Proposed Minor Change

RE: Proposed Minor Change

RE: 105 Constitution Blvd

Proposed Field Change

Plan View

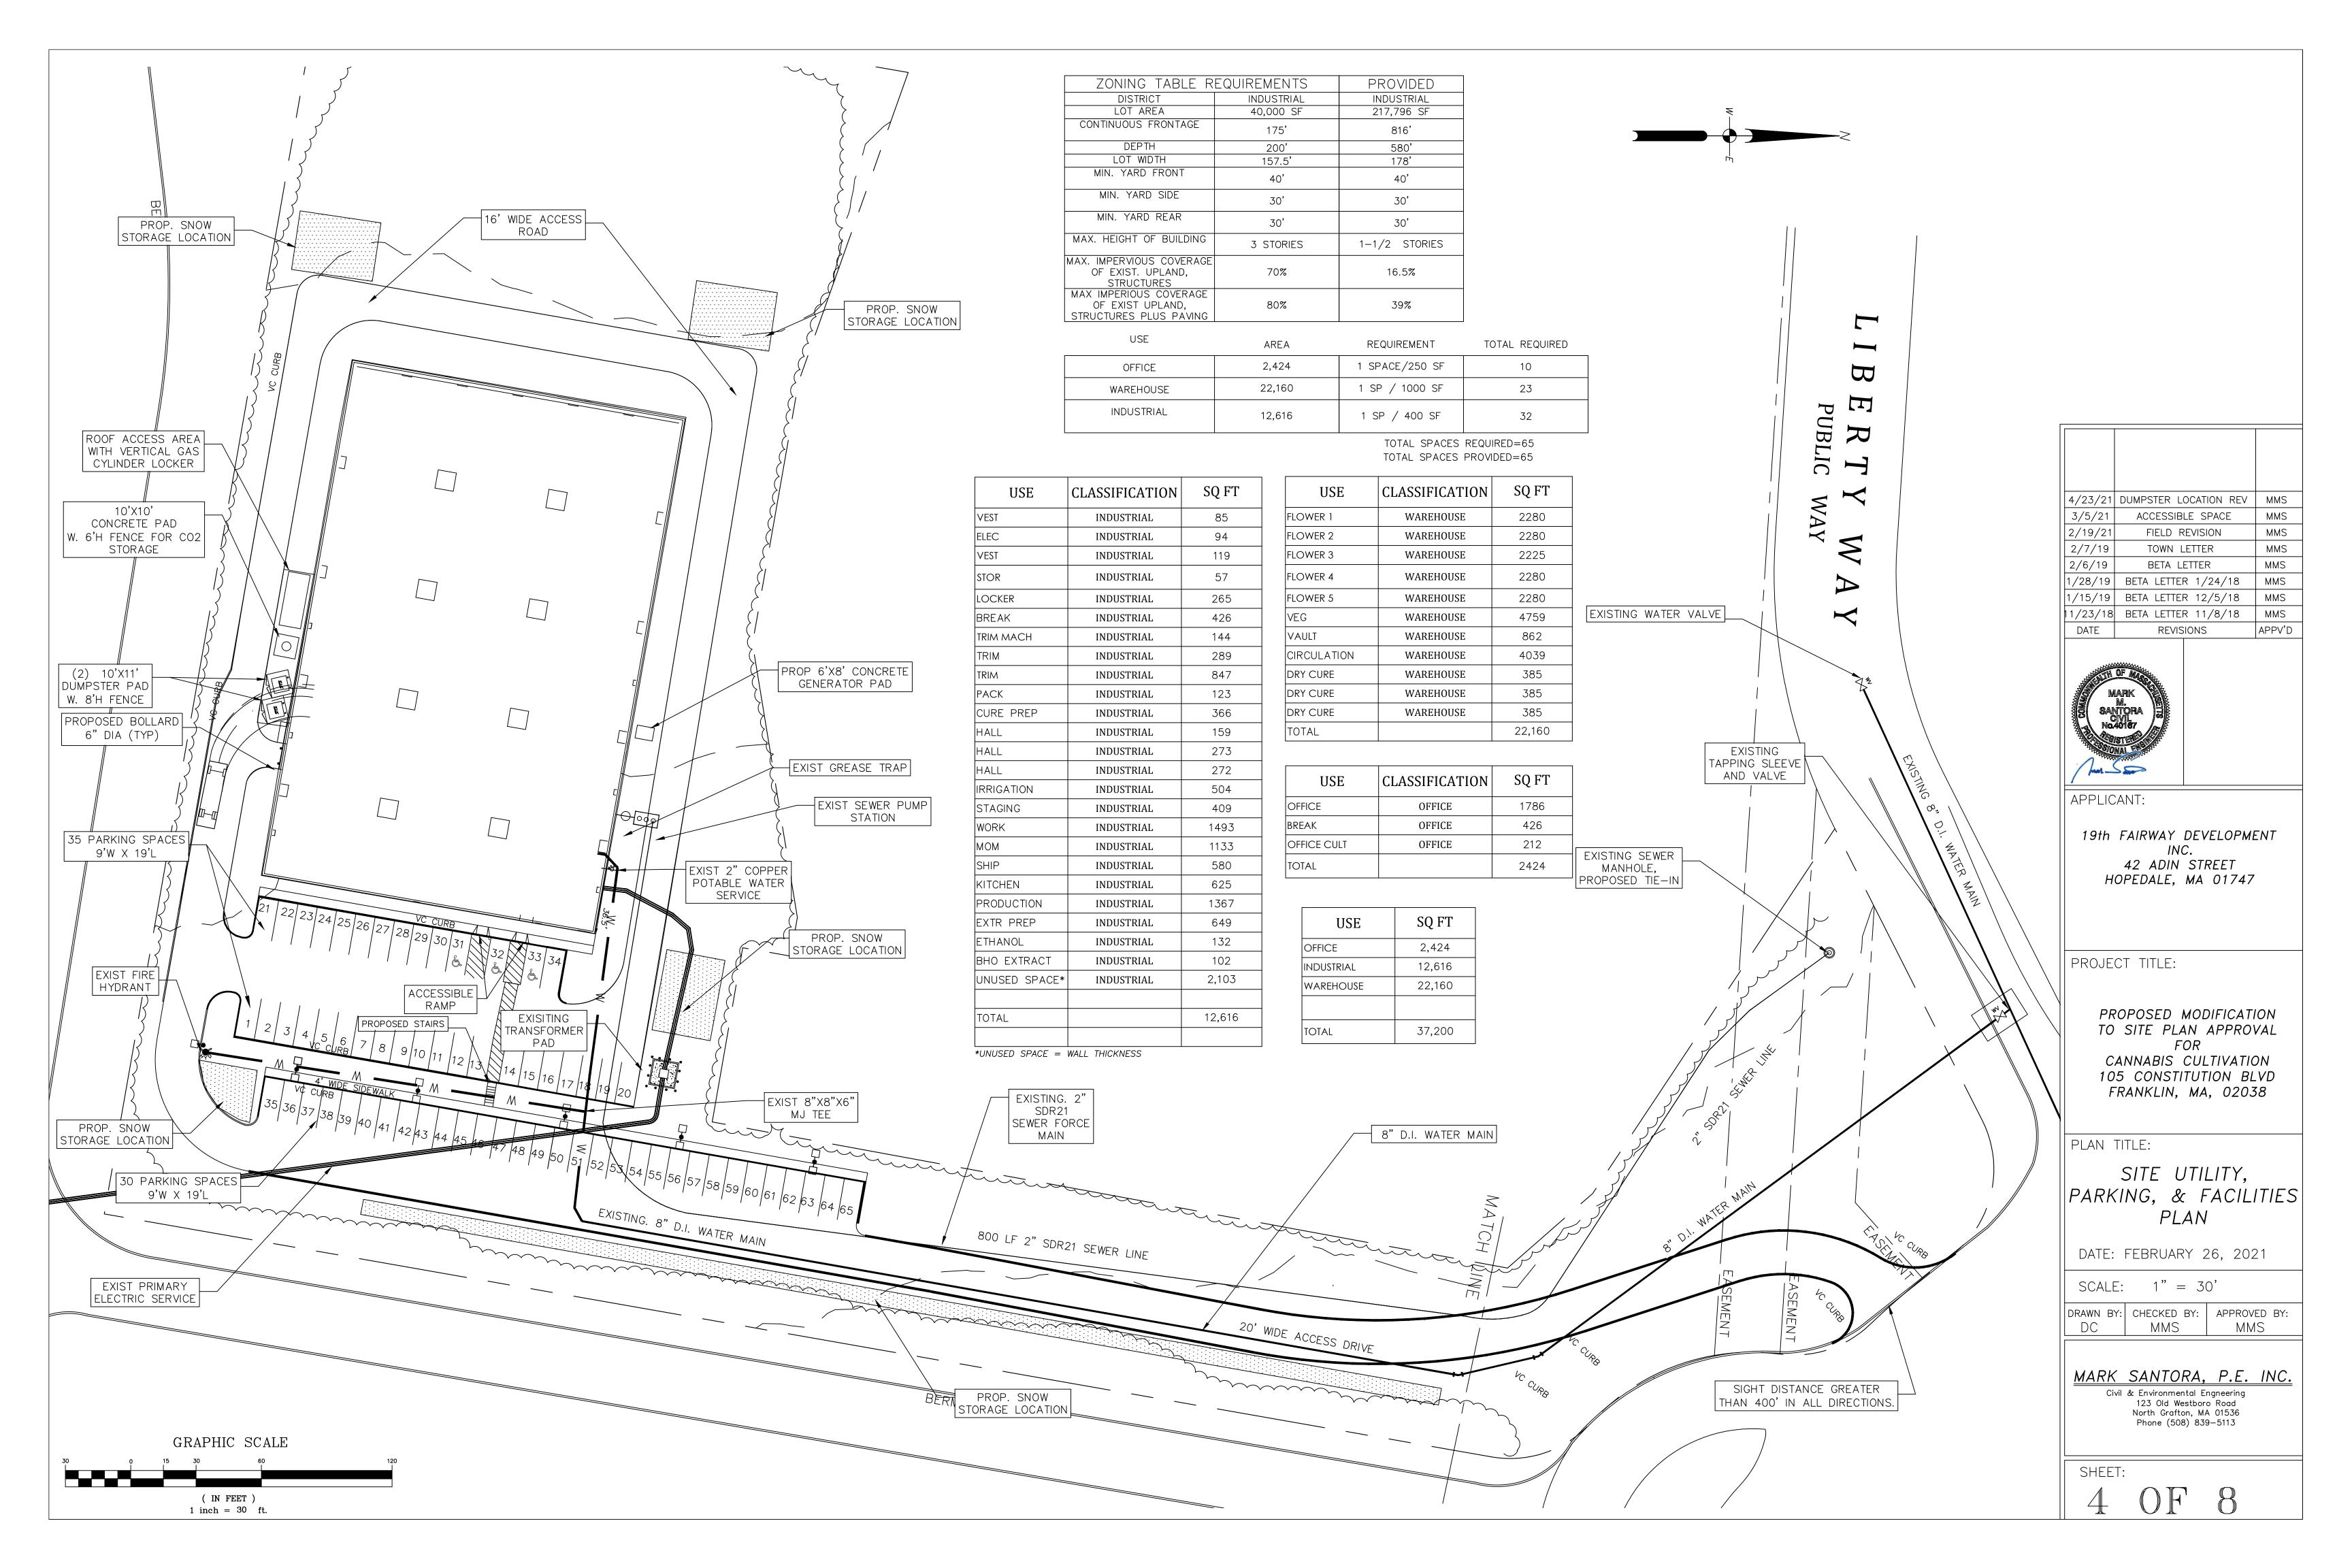
- 6. The owner would like to utilize LED wall pack lighting around the building. A revised photometric plan has been attached. The revised plan shows spillage over the property lines (previous did not). If they can revise the photometrics to conform to the original then a field change seems appropriate. In its current state, the Board would need to waive light spillage requirements.
